From: Selim <Selim@sawayaeng.com>
Sent time: 08/06/2018 01:57:37 PM
To: So Kim
Cc: Jill Martin <jmartin@trumpnational.com>
Subject: RE: Tract 50666 fencing Plan
Attachments: Exhibit Wall+fence+landscaping.pdf TTM-50666-Revised.pdf

EXHIBIT "A"
TRUMP NATIONAL GOLF CLUB
RETAINING WALL, FENCING AND LANDSCAPING EXHIBIT
TRACT NO. 50666

VESTING TENTATIVE TRACT 50666

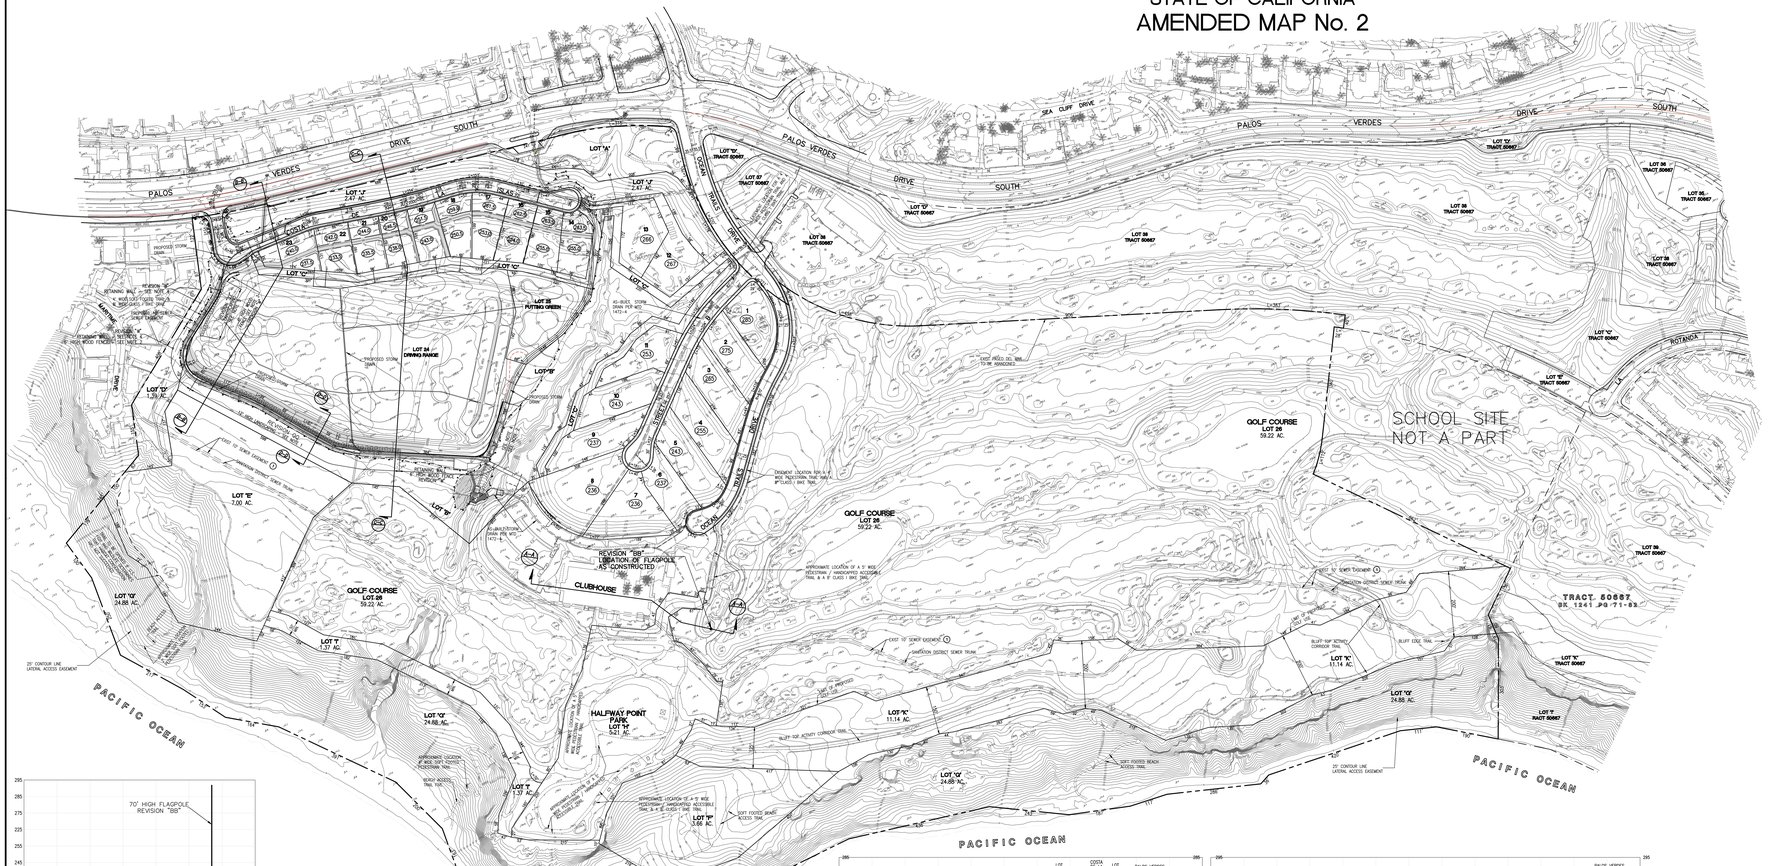
If I am not mistaken, and subject to confirmation, the condition to install a 6 foot fence at the west and south perimeter of the driving range was revised per revision QQ. A 6 foot lattice fence will only be required on top of the existing stone wall. (see attached fencing exhibit and the revised TTM of 50666 for location)
